CIRCULAR LETTER NUMBER 28-2007

ROTAX
NEW AGE KARTING

SHIFT CONTACT ADJUSTMENT

We would like to inform you about the following technical change and technical adjustment on 125 MAX DD2 engine (all versions).

Adjustment of shift contact

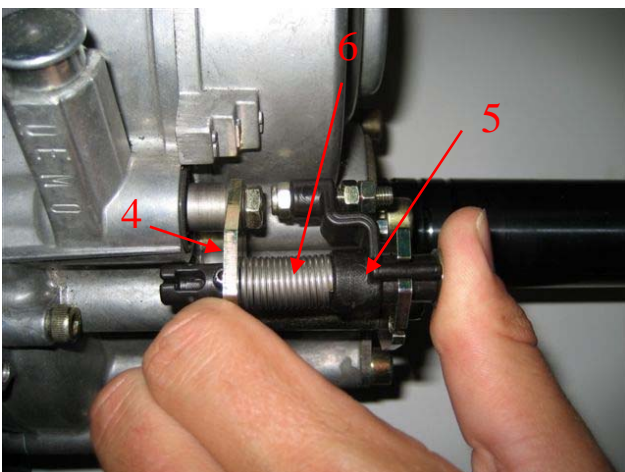
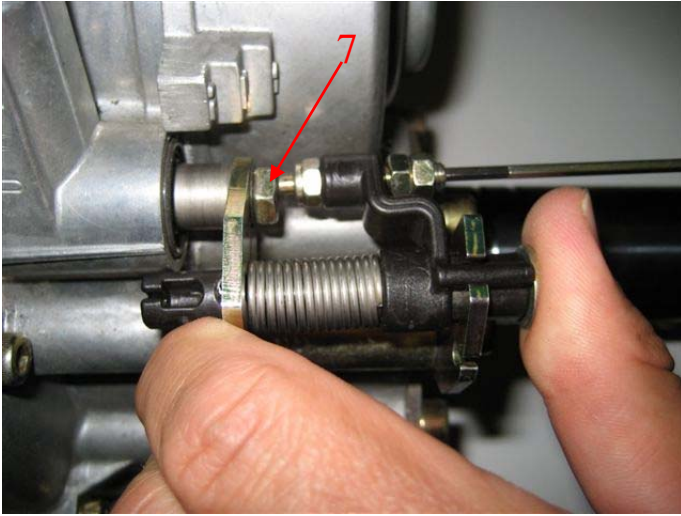
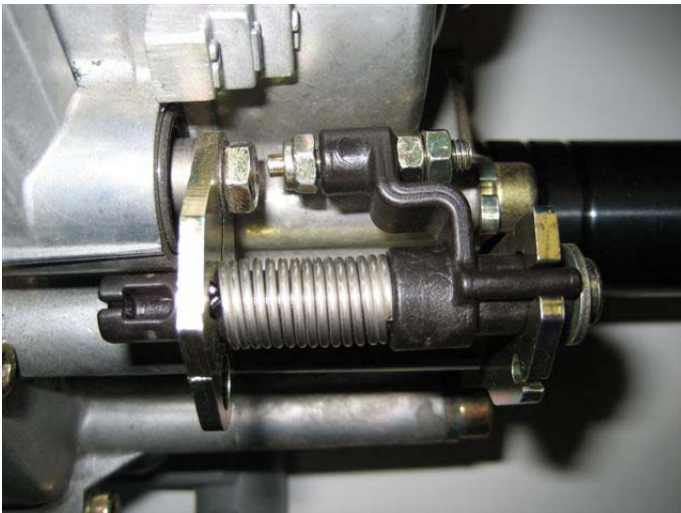
In the past we had some problems with wrong adjustments of the shift contact what caused shift contact 660531 breakings. To avoid assembly mistakes we introduce now to you the new adjustment procedure.

- ⇒ Loosen the (1) two hex nuts 242071 and the (2) lock nut 842030.
- ⇒ Turn the (3) adjustment screw 440781 into the (2) lock nut 842030 until it aligns.

- ⇒ Press the (4) retaining plate and the (5) shift contact together until the (6) compression spring is completely pinched.

⇒ Turn the (3) adjustment screw 440781 in until it stops on the (7) hex screw 240381.

Note: Verify that you don't overturn the (3) adjustment screw 440781 to avoid breaking of the (5) shift contact arm.

- ⇒ Release now the (6) compression spring 238410.
- ⇒ Turn the (3) adjustment screw 440781 now with an allen key a half turn in.
- ⇒ Tighten the (1) two hex nuts 242071 and the (2) lock nut 842030.

Technical Change

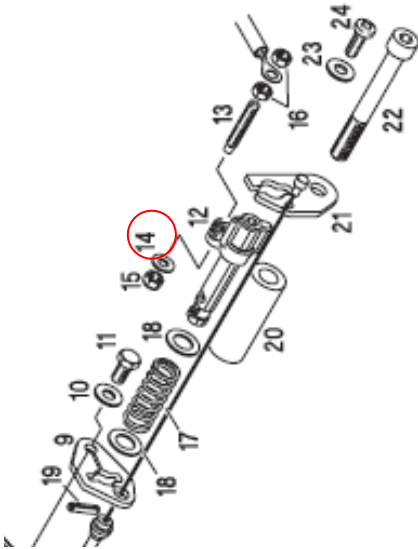
The (14) washer 927571 is not any more implemented in the shift contact system on the 125 MAX DD2 engine.

The reason for removing the washer is that the (13) adjustment screw 440781 get completely tighten throw the whole length of the (15) lock nut 842030.

Washers are conducted in the Technical Regulation 2007 as a non-tech part and therefore not relevant.
